**REPORT OF THE CITY OF CORAL GABLES
HISTORICAL RESOURCES & CULTURAL ARTS DEPARTMENT
TO THE HISTORIC PRESERVATION BOARD
ON THE DESIGNATION OF
THE PROPERTY AT
3701 DURANGO STREET
CORAL GABLES, FLORIDA
AS A LOCAL HISTORIC LANDMARK AND
SPECIAL CERTIFICATE OF APPROPRIATENESS
FOR ALTERATIONS AND ADDITIONS TO THE PROPERTY**

LOCAL HISTORIC DESIGNATION REPORT – LHD 2018-005

**SPECIAL CERTIFICATE OF APPROPRIATENESS REPORT
COA (SP) 2018-005**

**Figure1: Extant historic sill, 1925
West Façade, North Elevation of Original Porch**

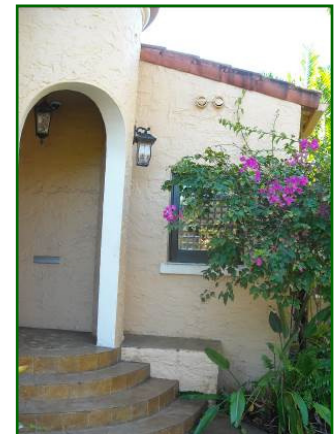
Many of the original sills were removed from the 1925 portion of the home. This proposal seeks to re-instate these sills. The extant original sill on the west façade (north façade of original screened porch – See Figure 1) will be the model for the re-instated wills. All re-instated sills on the 1925 original facades are to match the size, shape and texture of this sill. Their locations are noted on the plans.

*Note: All re-instated historic sills are to
match this sill in size, shape and
texture*

1. Staff requires shop drawings for the metal balcony railing.
2. The sills to be re-instated on the original home are to match in size, shape, and texture the extant sill next to the entry tower on the Durango Street façade (see above). An in situ mockup of a re-instated sill must be approved by Staff prior to full-scale installation.
3. The sills of the new windows are to be differentiated from the re-instated original sills.
4. Staff will review paving materials, detailing and materials of the fountains and other courtyard and terrace elements
5. All window muntins are to be high-profile

Figure 2: Lots 1-3, Block 43, Coral Gables Country Club Section 3

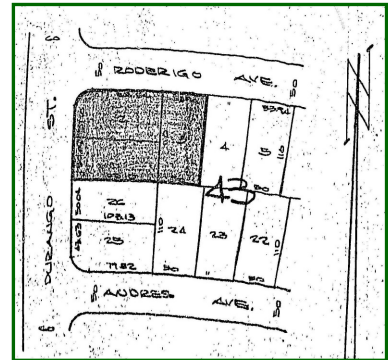
Grant a variance to allow the proposed additions to have a rear setback of approximately eight feet two inches (8'-2") vs. A minimum rear setback of ten (10) feet shall be maintained and required on all buildings as required by Article 4, Section 4-101 (D) (4c) of the Coral Gables Zoning Code.

This property is comprised of three lots. Lots 1 and 2 run east-west and lot 3 runs north-south. The narrow end of a lot is considered to be its front. Hence, this property is considered to have two frontages, one along Durango Street corresponding to Lots 1 and 2 and the other along Roderigo Avenue corresponding to Lot 3. Therefore, the property technically has two rears. The standard minimum rear setback of 10' along the south and east property lines is required. The applicant is requesting an 8'-6" setback along the south property line. Since the setback along the south property line would be 5' if it were to be considered a side of the property Staff supports this variance request.
